# 100 Mount Street, North Sydney (MP08-0241)

Section 75W - MOD 2  
Environmental Assessment Report

December 2013

FIGURE 1 – NORTHERN FAÇADE

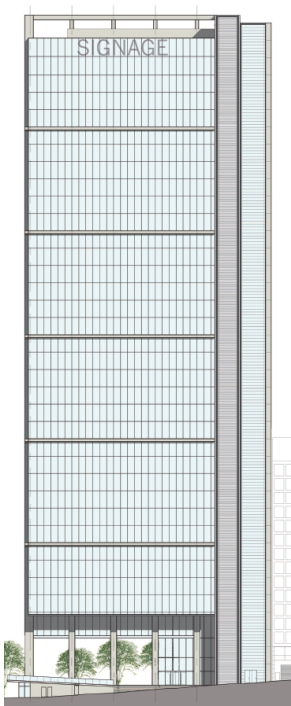
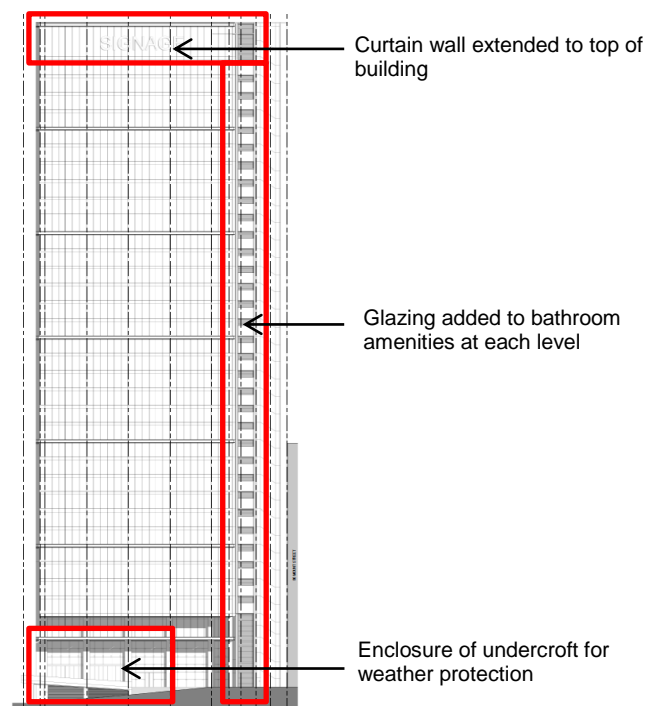
Proposed modification to the Northern façade include:

- Extension of the curtain wall screen to the uppermost point of the building to enclose plant and other structural building elements, previously exposed (refer to **Picture 2** below), for improved aesthetics;
- Removal of portions of louvres from the spine section of the north elevation running from the top to bottom of the façade. This forms windows for bathrooms, taking advantage of views and increasing light to the building; and
- Glazing introduced to ground floor lobby level to enclose space.

FIGURE 2 – SCREENED SPINE AND UPPER TREATMENT ON NORTH & SOUTH ELEVATIONS

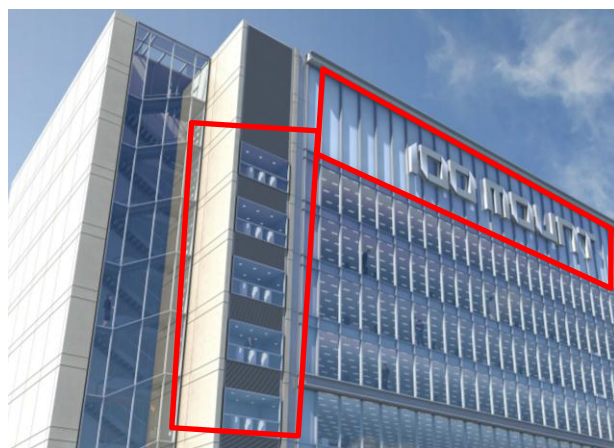
- Removal of portion of louvres to form windows in the screened spine section of the north and south elevations; and
  - modification to the structural steel brace feature to the eastern elevation.

FIGURE 3 – EASTERN ELEVATION

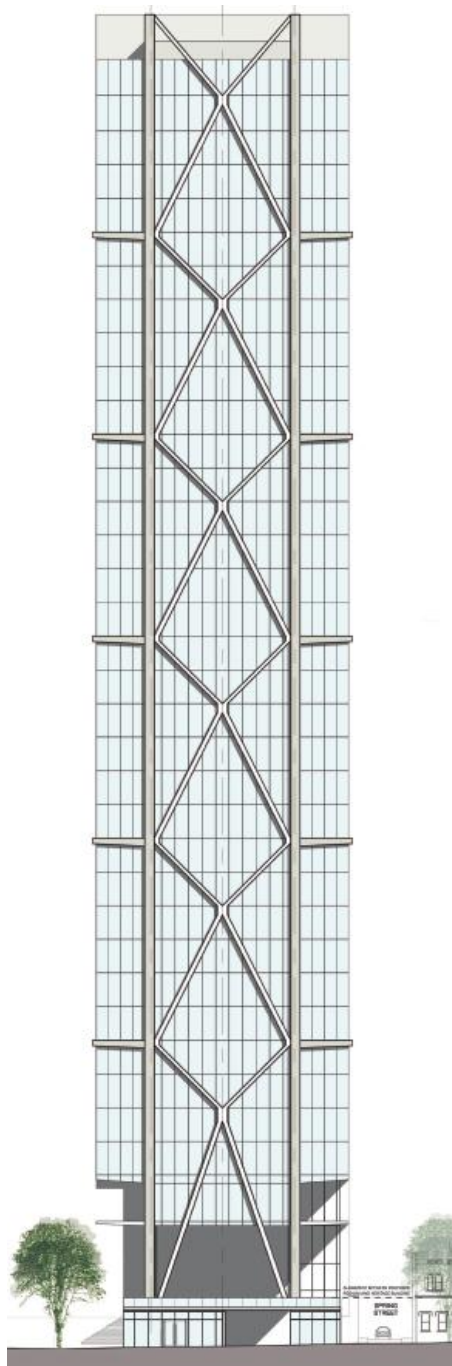
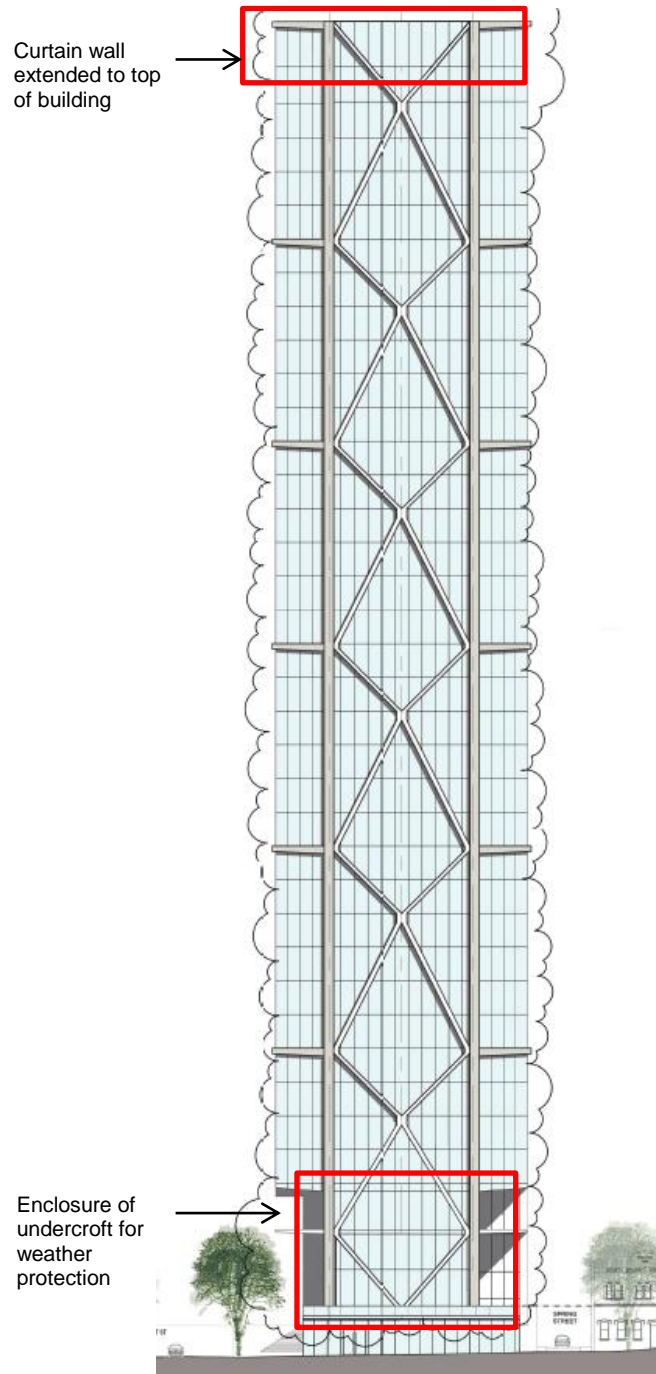
Proposed modifications to the Eastern façade include:

- The structural brace running from the ground floor to the roof on the east elevation modified to improve the design both structurally and aesthetically;
- Extension of the curtain wall screen to the uppermost point of the building to enclose plant and other structural building elements previously exposed to refine building aesthetics; and
- Additional glazed wall at ground level added to enclose undercroft space.

FIGURE 4 – SOUTHERN FACADE

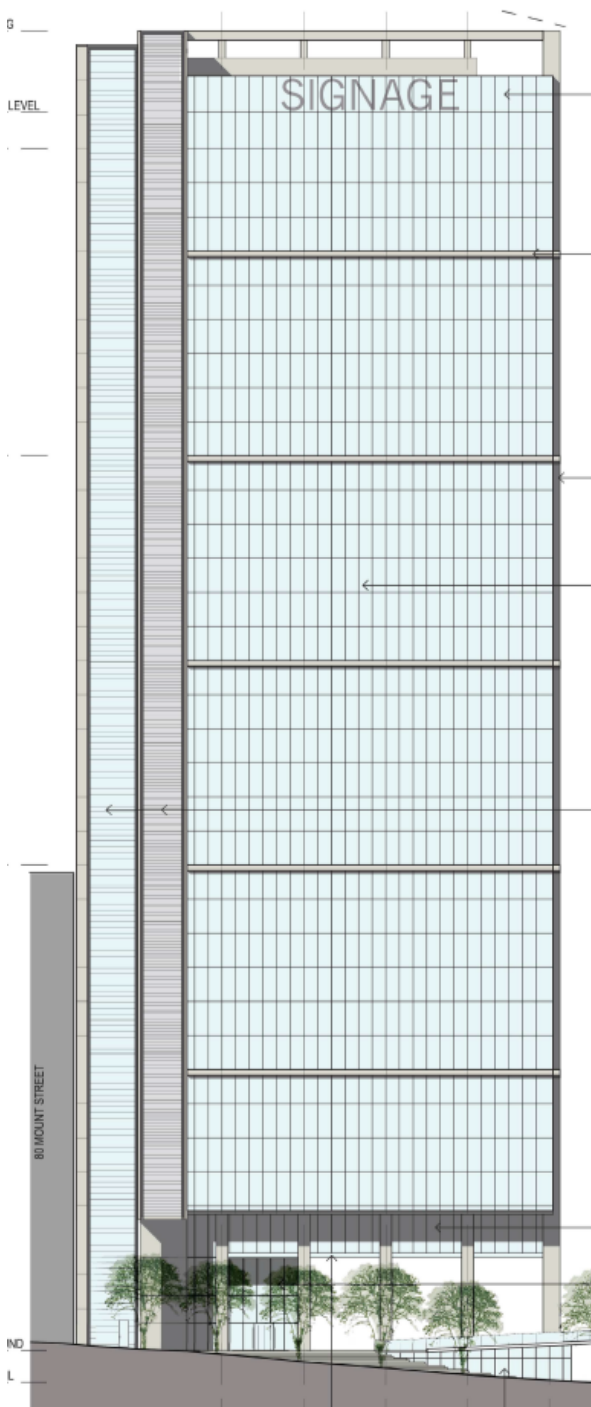
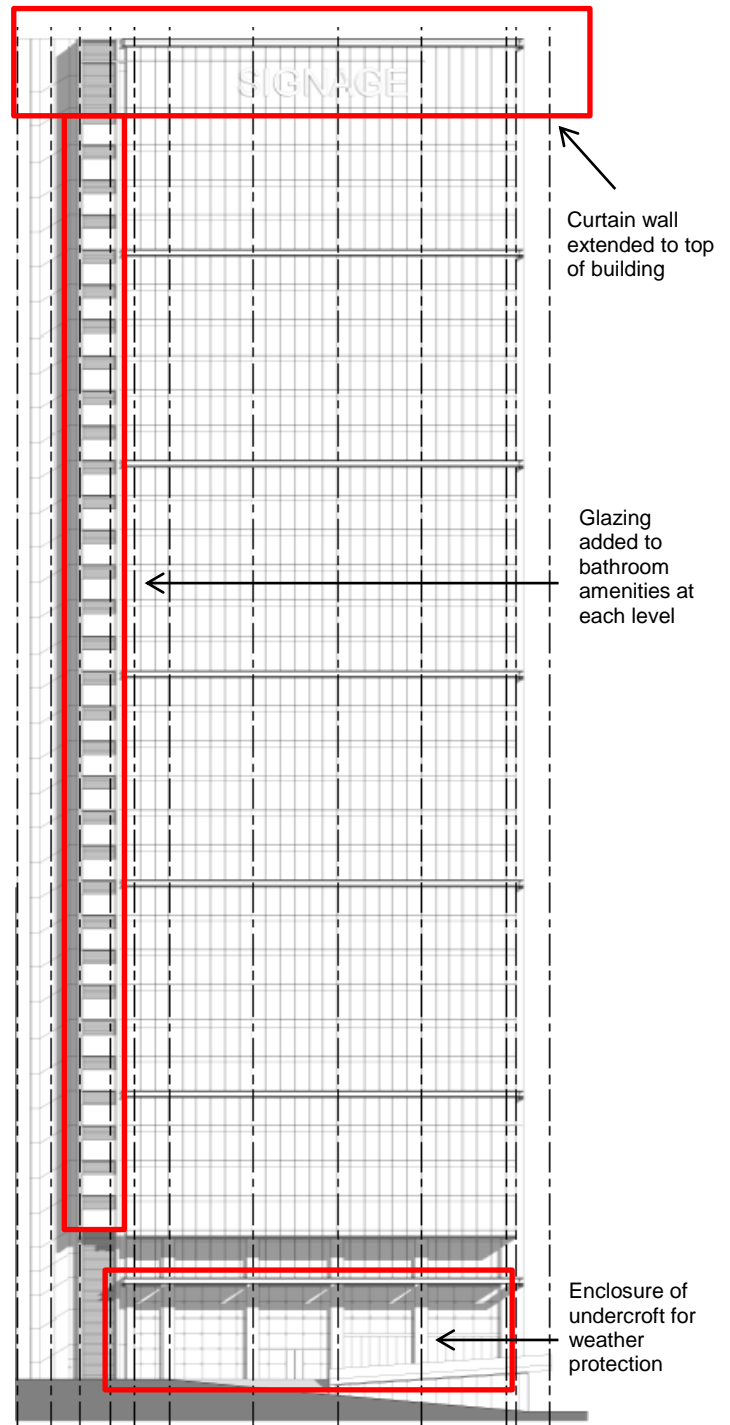
Proposed modifications to the Southern façade include:

- Extension of the curtain wall screen to the uppermost point of the building to enclose plant and other structural building elements previously exposed, creating a sleeker aesthetics; and
- Removal of portions of louvres from the spine section of the north elevation running from the top to bottom of the façade. This forms windows for bathrooms, taking advantage of views and increasing light to the building.

FIGURE 5 – LEVEL B6

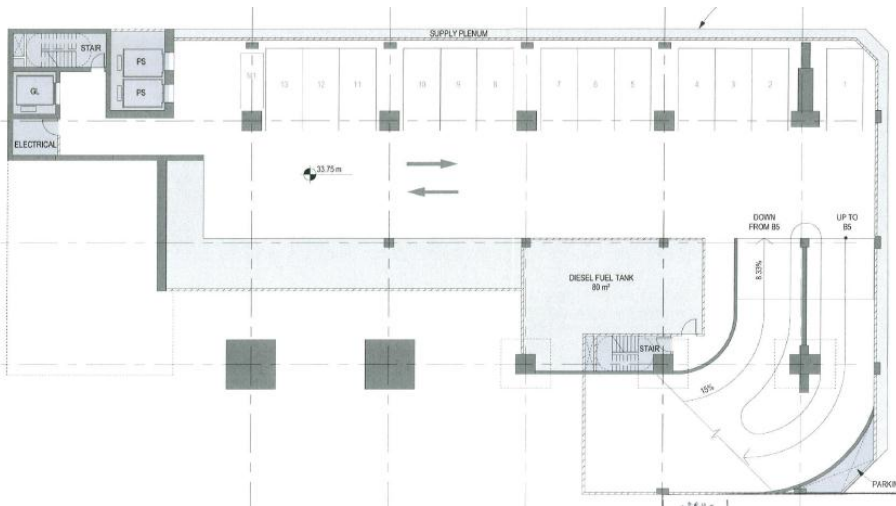
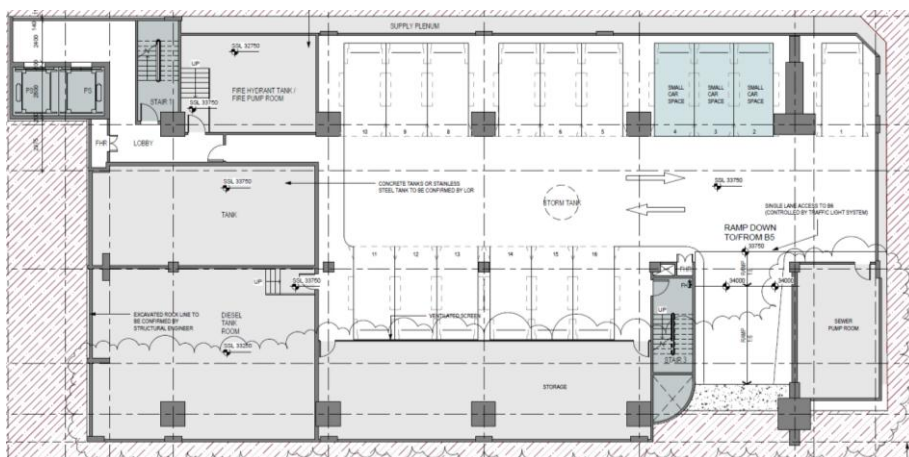
- Additional excavation to enlarge the southern portion of level B6 and provide additional storage rooms / space and allowing for the modifications listed below;
- Enlargement and relocation of the diesel fuel tank to the south western corner of this level;
- Access ramp relocated with a new sewer pump room located in former ramp location;
- Enlarged diesel tank room relocated to the south western corner of this level;
- New fire hydrant tank / fire pump room and tank rooms added to north western corner;
- Lifts reconfigured; and
- Car parking on this level increased from 13 to 16 spaces.

FIGURE 6 – LEVEL B5

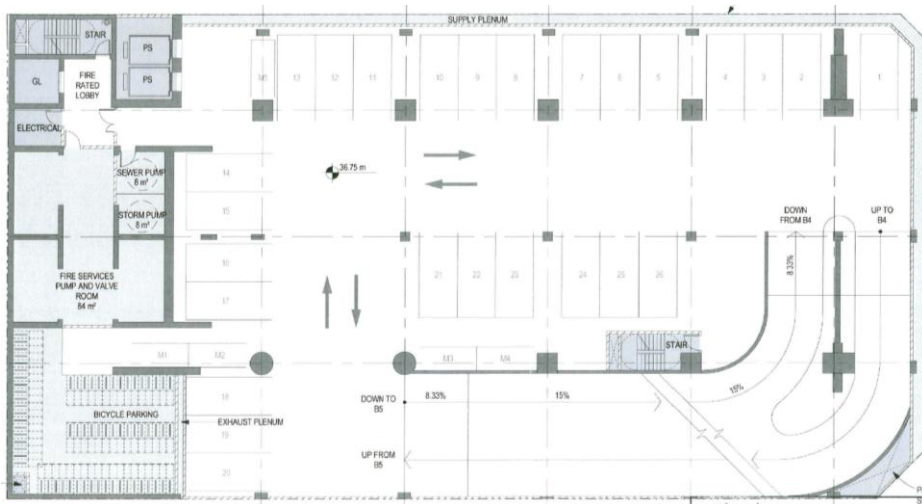
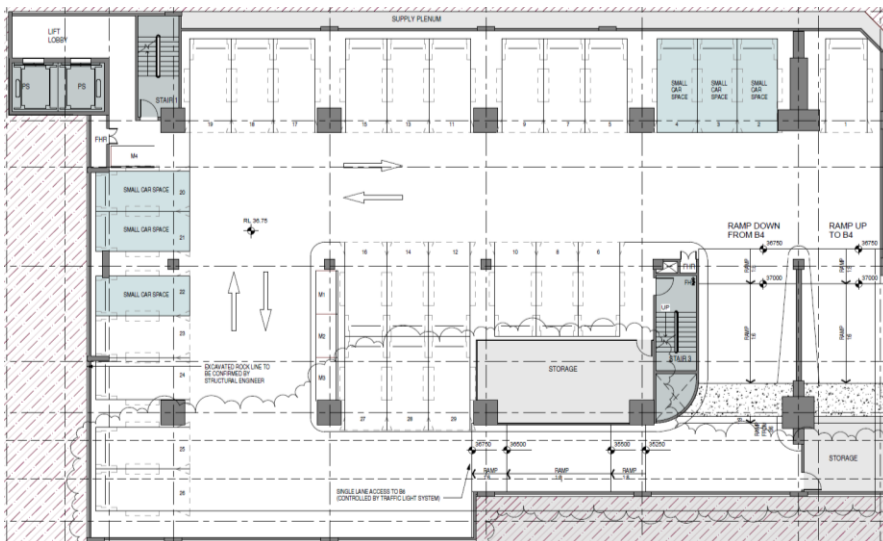
- Modification to car parking layout and shape;
- Reduction in excavation to south eastern corner To suit CBD Rail Link excavation requirements;
- Narrowing of vehicle ramp to a single lane to be controlled by a traffic light system;
- Relocation of bicycle parking from the south west portion of this level to Level B2;
- Two additional storage rooms added;
- Fire services pump / valve room relocated to Level B6;
- Lifts reconfigured; and
- Parking increased on this level from 26 to 29 spaces.

FIGURE 7 – LEVEL B4

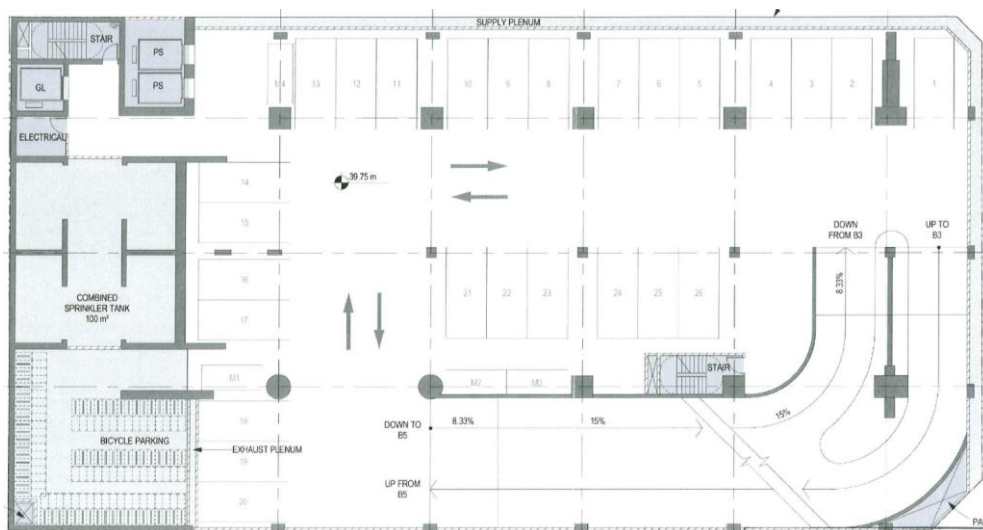
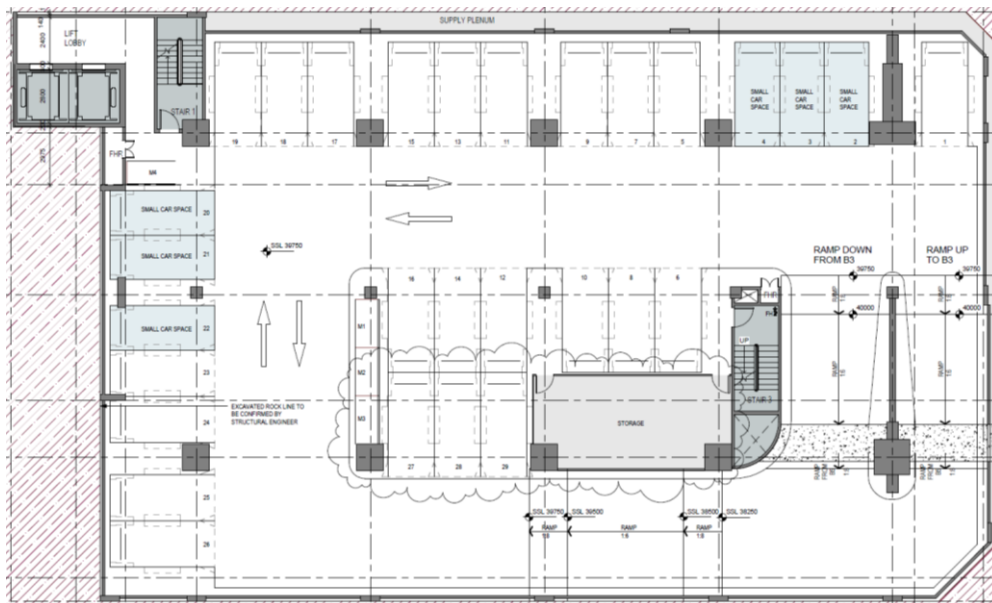
- Reduction in excavation to south eastern corner to suit CBD Rail Link excavation requirements;
- Additional storage room added;
- Bicycle parking relocated to Level B2;
- Sprinkler tank relocated to Level B6;
- Lifts reconfigured; and
- Parking increased on this level from 26 to 29 spaces.

FIGURE 9 – LEVEL B2

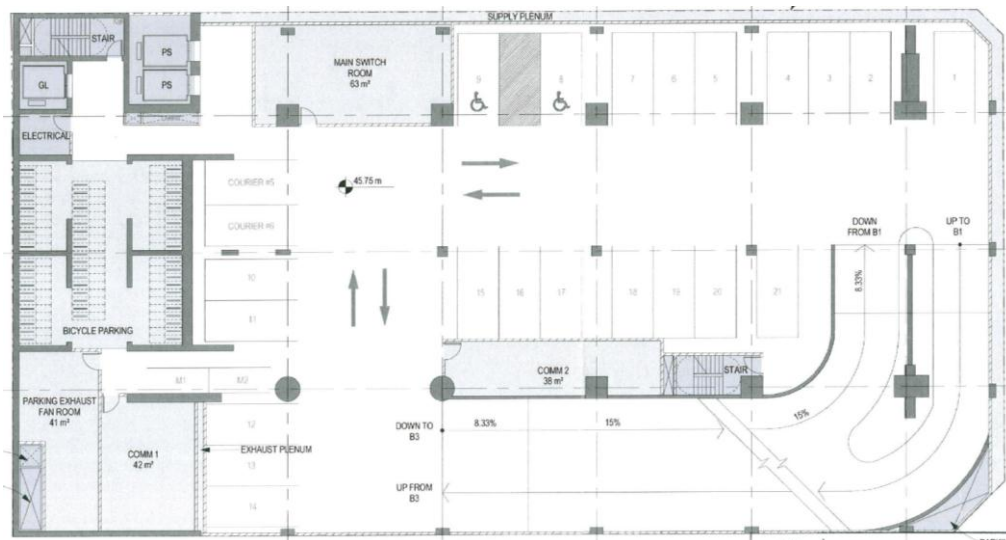
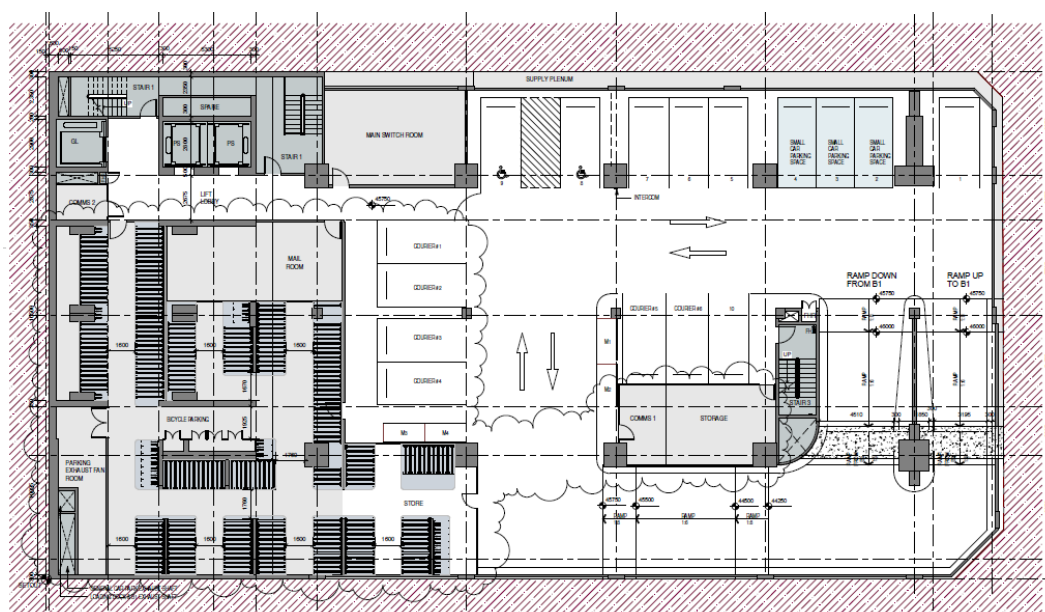
- New enlarged bicycle parking area, absorbing bicycle parking from levels B3, B4 & B5;
- Parking exhaust fan room and one of the communication rooms replaced by mail and store rooms; and
- 21 parking spaces reduced to 10, and 2 courier spaces increased to 6.

FIGURE 10 – LEVEL B1

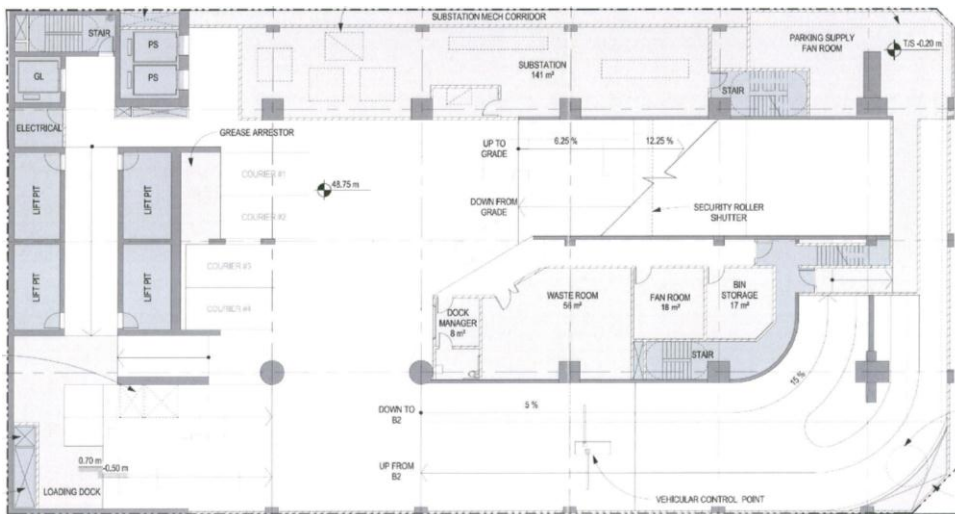
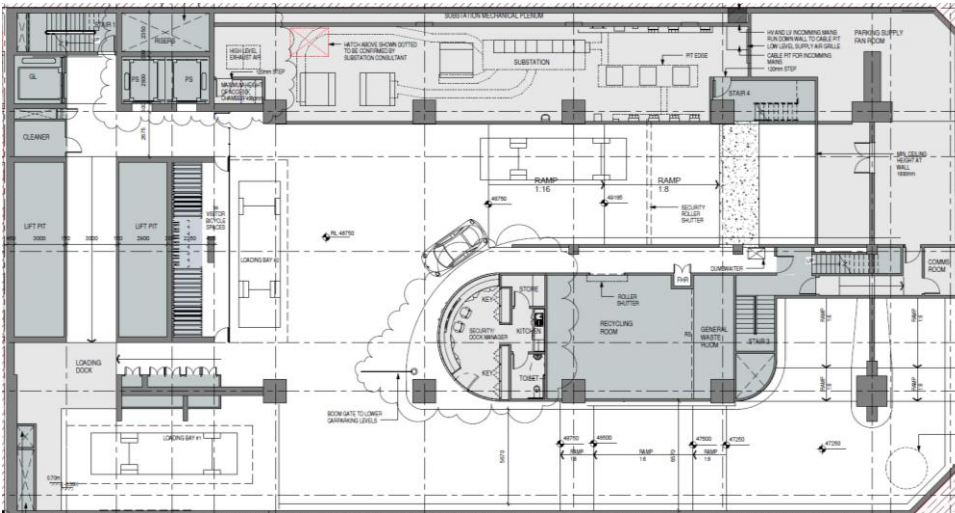
- 4 x Courier car parking spaces replaced with 2<sup>nd</sup> truck loading bay;
- Additional visitor bicycle storage bay added;
- Boom gate added to restrict access to lower car parking levels;
- New security / dock manager space and amenities added adjacent to proposed boom gate;
- Lifts reconfigured; and
- Plant including risers and exhaust intake modified in the north western corner of this level.
